DUKE POWER COMPANY

Re: Catawba Nuclear Station, Unit 1  
Docket No. 50-413  
Draft Technical Specifications

Attachments 1-5 of this letter contain proposed amendments to the Draft Technical Specifications for Catawba Unit 1. Each attachment contains the proposed changes and a discussion of the justification.

FIGURE 3.2-3

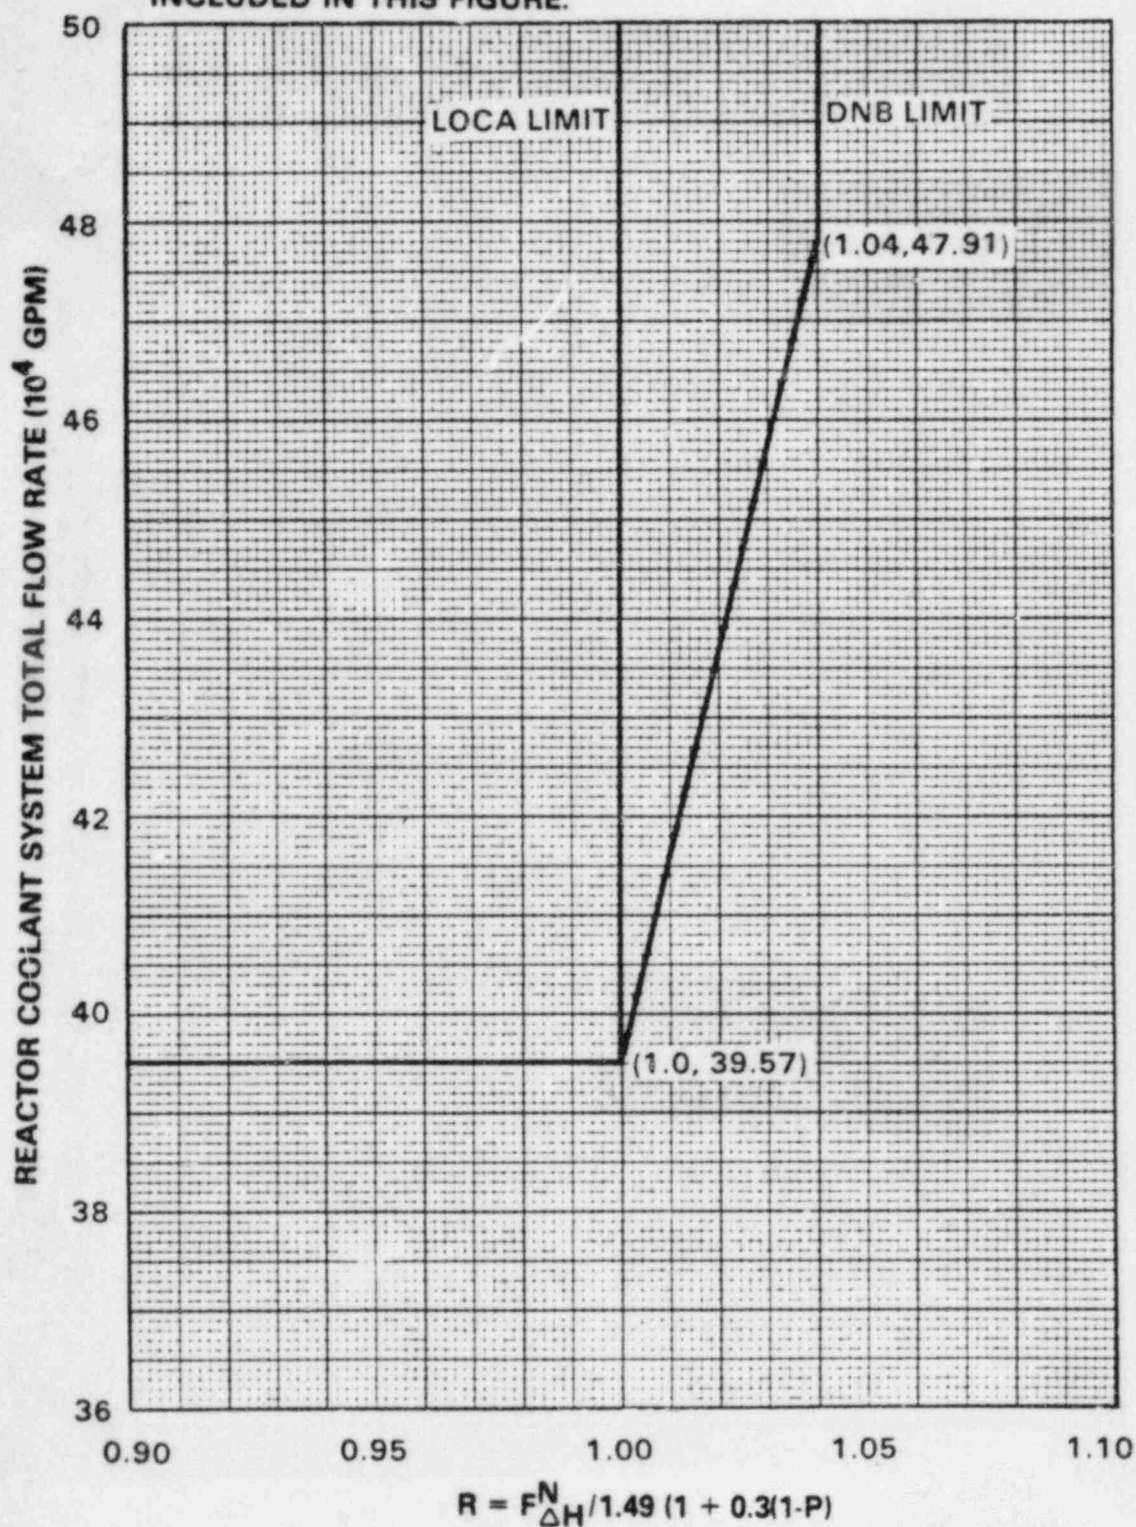
3.2.3 The combination of indicated Reactor Coolant System total flow rate and R shall be maintained within the region of allowable operation shown on Figure 3.2-3 for four loop operation.

c.  $F_{\Delta H}^N$  = Measured values of  $F_{\Delta H}^N$  obtained by using the movable incore detectors to obtain a power distribution map. The measured values of  $F_{\Delta H}^N$  shall be used to calculate R since Figure 3.2-3 includes penalties for undetected feedwater venturi fouling of 0.1% and for measurement uncertainties of 2.1% for flow and 4% for incore measurement of  $F_{\Delta H}^N$ .
